PLANNING AND ZONING CASE CHECKLIST

P&Z CASE # SP2019-023 P&Z DATE 6/25/2019 ^{P&Z} CC DATE 7/9/2019 APPROVED/DENIED
ARCHITECTURAL REVIEW BOARD DATE _____ HPAB DATE _____ PARK BOARD DATE _____

Project Number: SP2019-023
Project Name: Site Plan for Mixed-Use Development
Project Type: SITE PLAN
Applicant Name: WIER & ASSOCIATES, INC
Owner Name: GOLIAD REAL, ESTATE LLC
Project Description:

PLANNING AND ZONING 1ST ROUND STAFF COMMENTS(06.20.2019):

**SITE PLAN
 MIXED-USE DEVELOPMENT
 3009 N. GOLIAD ST
 ROCKWALL, TEXAS**

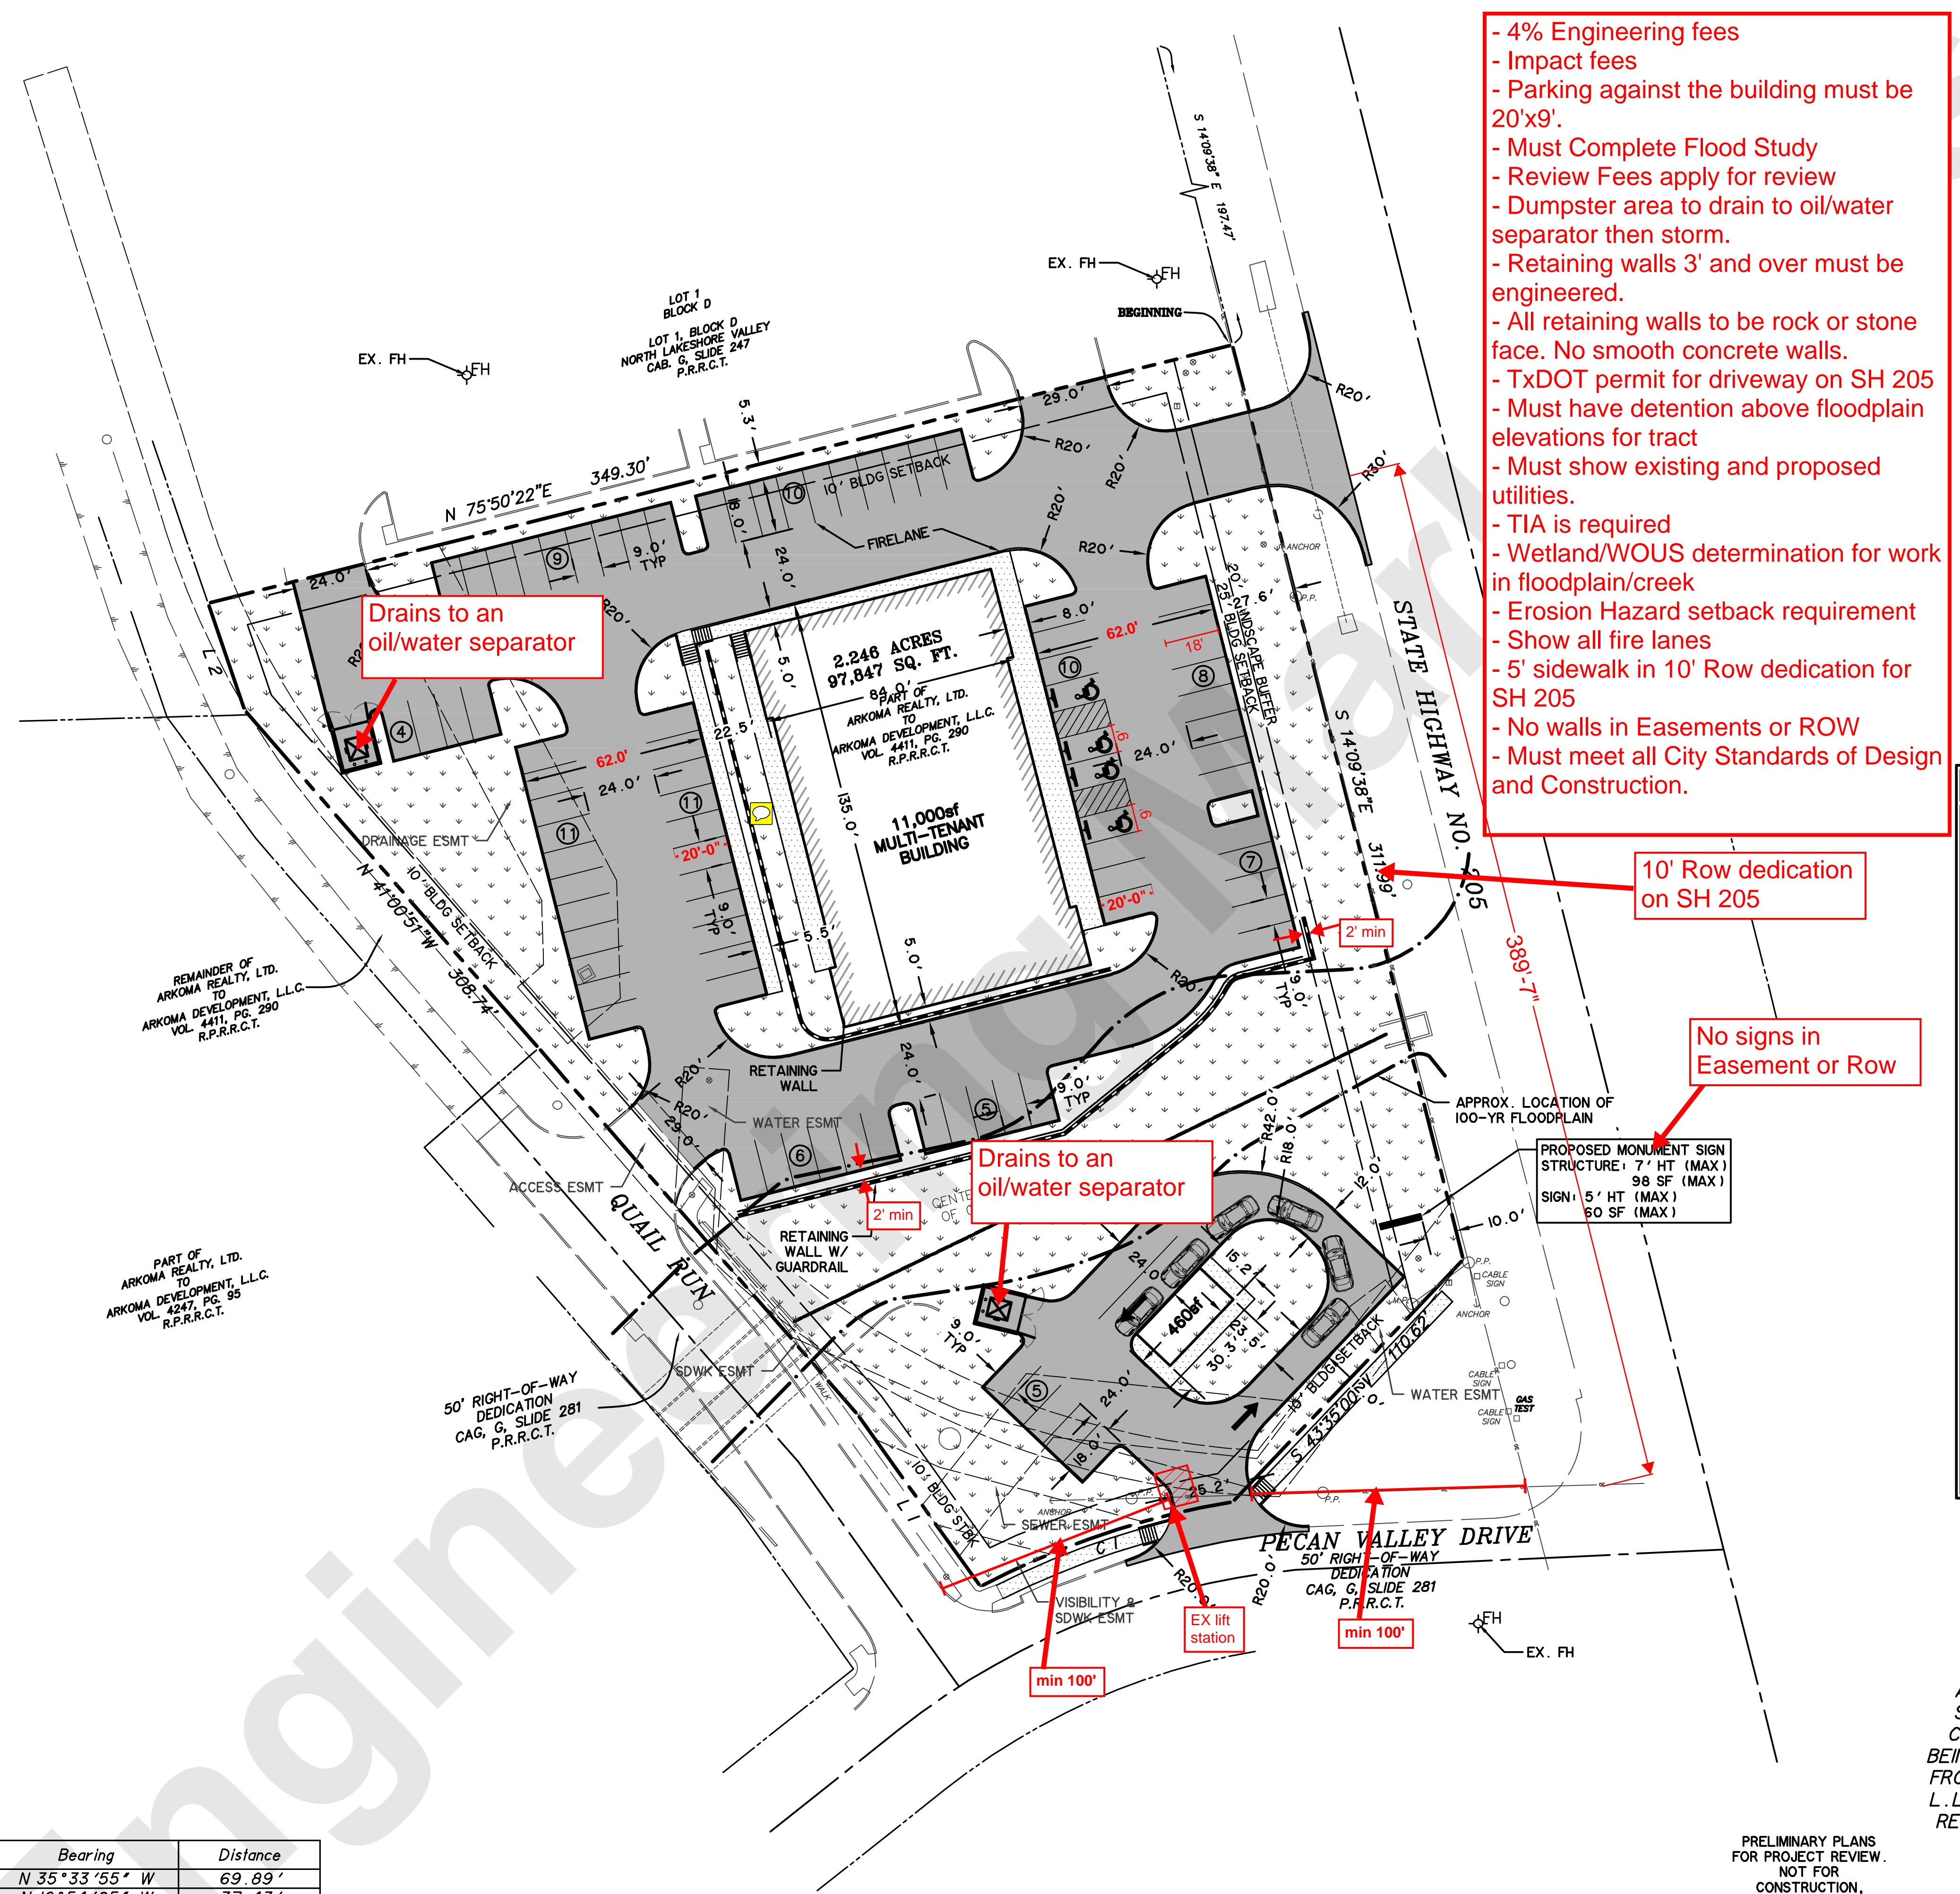
- 4% Engineering fees
- Impact fees
- Parking against the building must be 20'x9'.
- Must Complete Flood Study
- Review Fees apply for review
- Dumpster area to drain to oil/water separator then storm.
- Retaining walls 3' and over must be engineered.
- All retaining walls to be rock or stone face. No smooth concrete walls.
- TxDOT permit for driveway on SH 205
- Must have detention above floodplain elevations for tract
- Must show existing and proposed utilities.
- TIA is required
- Wetland/WOUS determination for work in floodplain/creek
- Erosion Hazard setback requirement
- Show all fire lanes
- 5' sidewalk in 10' Row dedication for SH 205
- No walls in Easements or ROW
- Must meet all City Standards of Design and Construction.

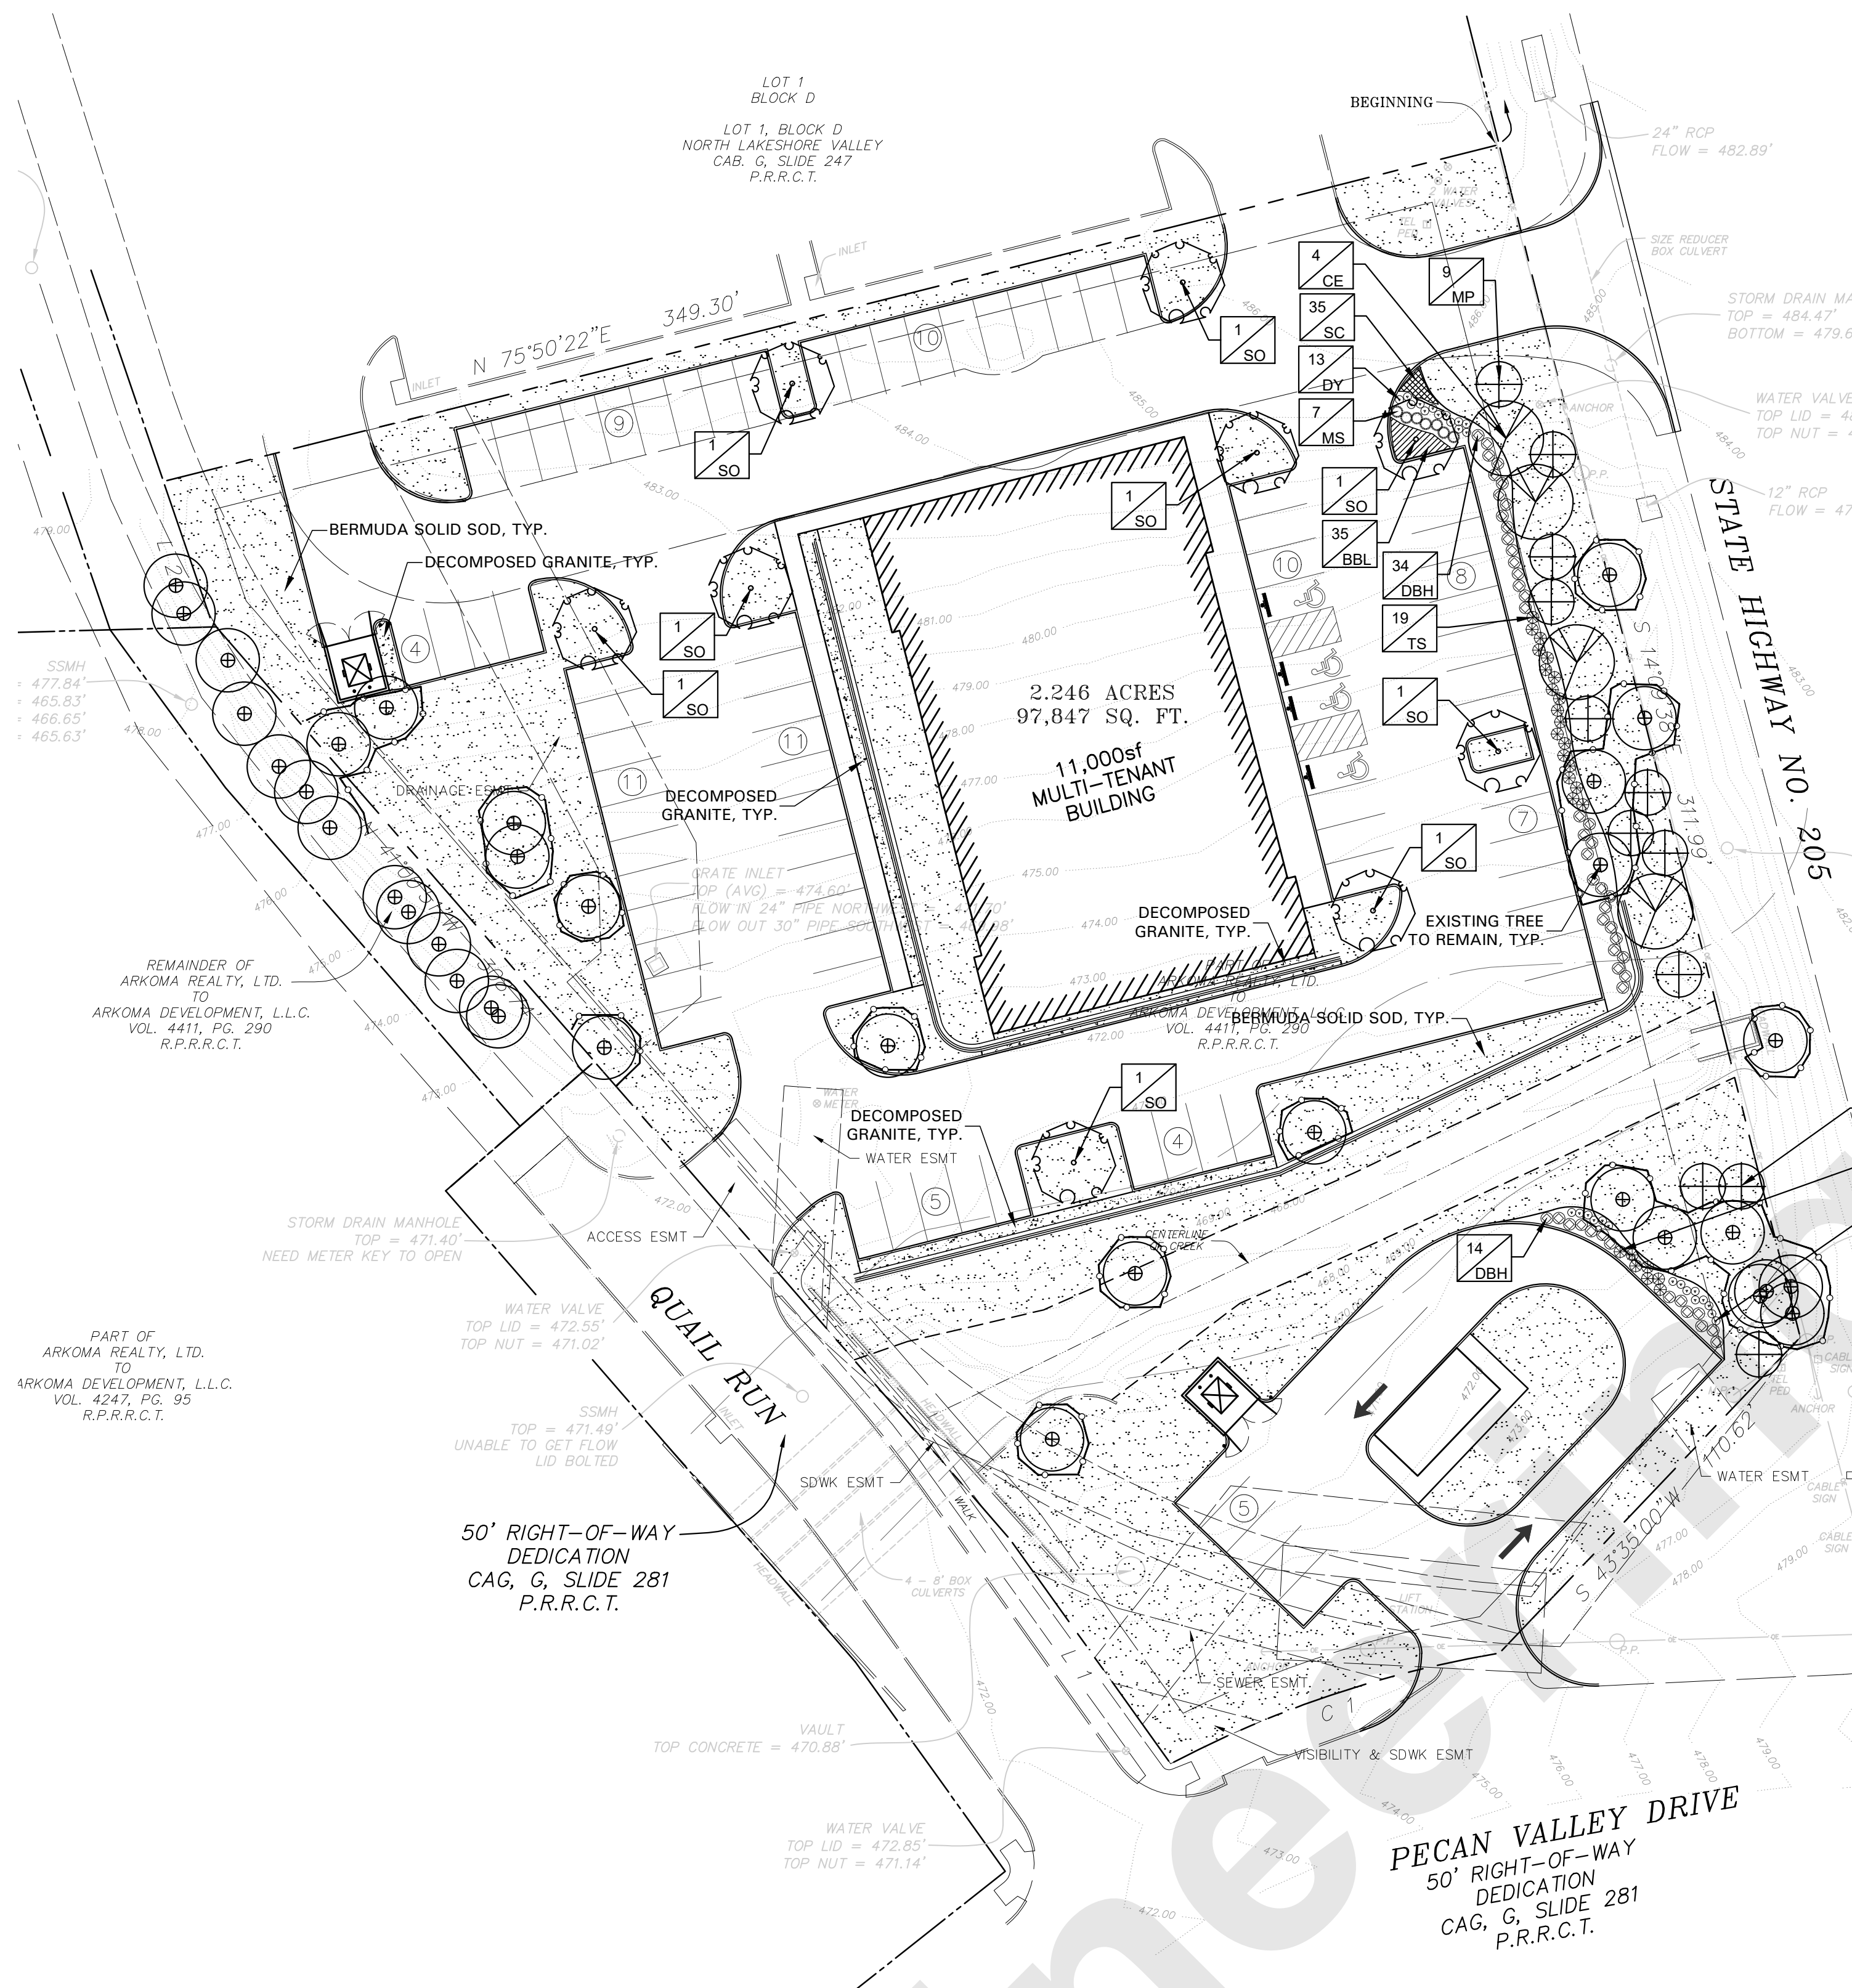
- Must show existing and proposed utilities
 - Trees must be at least 5' away from utilities
 - Need to show 10' SH 205 ROW dedication & Trees out of ROW
